OUR REF: 5941- EXTSEW2

YOUR REF: COM/2022/61

**RE: RESPONSE TO INFORMATION REQUEST FOR COM/2022/61
MAJOR CIVIL WORKS AND TREE WORKS TO FACILITATE THE EXTERNAL
TRUNK GRAVITY SEWER MAIN FOR VANTAGE YATALA INDUSTRIAL
DEVELOPMENT (STAGE 2)**

**Property: Lot 501 on SP295994, 60 Stapylton Jacobs Well Road, Stapylton, QLD 4207
Lot 334 on SP193431, 84 Christensen Road, Stapylton, QLD 4207
Lot 37 on SP222486, Christensen Road, Stapylton, QLD 4207
Lot 6 on SP274108, Christensen Road South, Stapylton, QLD 4207**

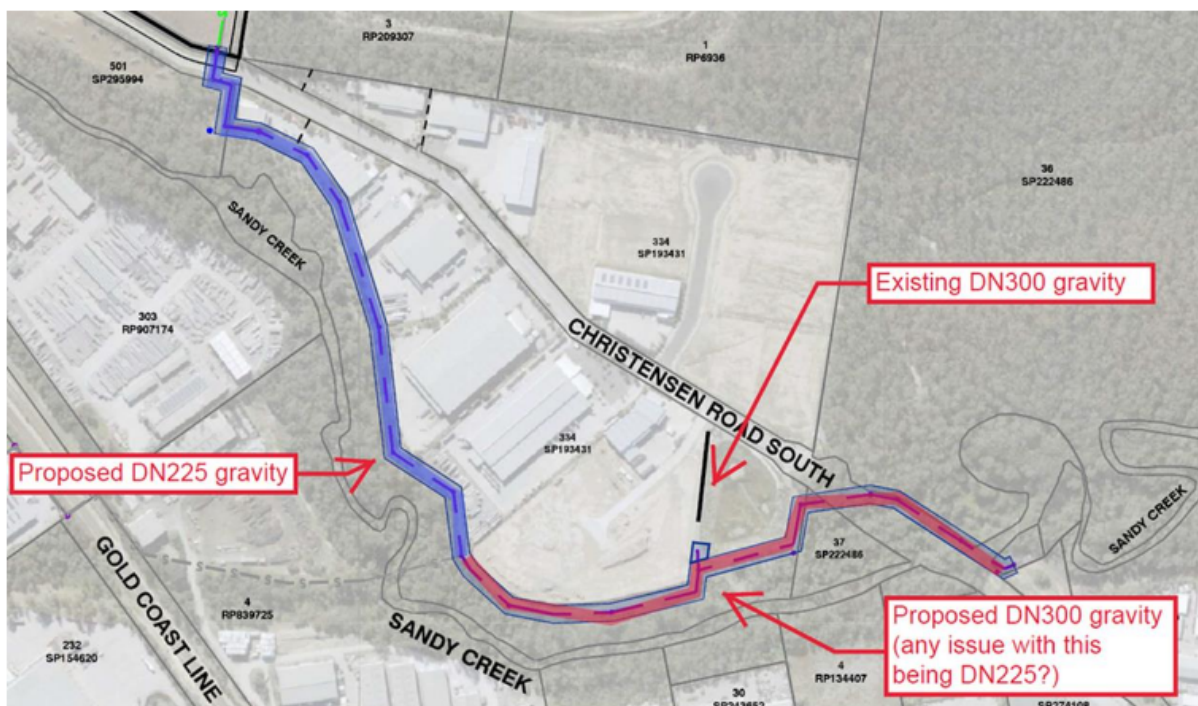
4. Council note the currently proposed gravity sewer design diameter as being 225mm and (partly) 300mm, however this section of trunk gravity sewer is intended to be wholly 225mm diameter as per WSSIP 2019. To assist in review of the proposed design, Council request the Applicant to provide the following information:

a. Ultimate sewer flow and sewer loading from the Vantage Development to the proposed Stage 2 trunk gravity sewer,

b. Sewer flows used by the Applicant for the blue (225mm) and red (300mm) pipe sections shown on the plan below:

The following items (c) and (d) are based on the assumption and outcome that the provided information for items (a) and (b) above confirm there is no issue with reducing any section of existing 300mm gravity sewer main down to 225mm:

Amend drawings to reduce the diameter of all proposed DN300 gravity sewer sections down to DN225 as per WSSIP 2019. In doing so:

c. Amend all maintenance structures currently proposed as 1500mm diameter down to the smallest practical size (SEQ Code currently states for RIGGS: 1050mm or 1200mm diameter for nominal sewer size up to 225mm).

d. Amend all proposed enveloper pipes currently proposed as DN500 GRP down to the smallest practical size (SEQ Code currently states minimum DN425 encasing pipes for DN225 sewer pipes). Provide justification if enveloper pipes larger than DN425 are proposed.

Alternatively, justify why any sections of proposed gravity sewer main is required to be larger than DN225.

In response to Item, the applicant has worked with GCWW on the design of this trunk section of gravity main and the size has been further increased to 375m diameter per GCWW's request.
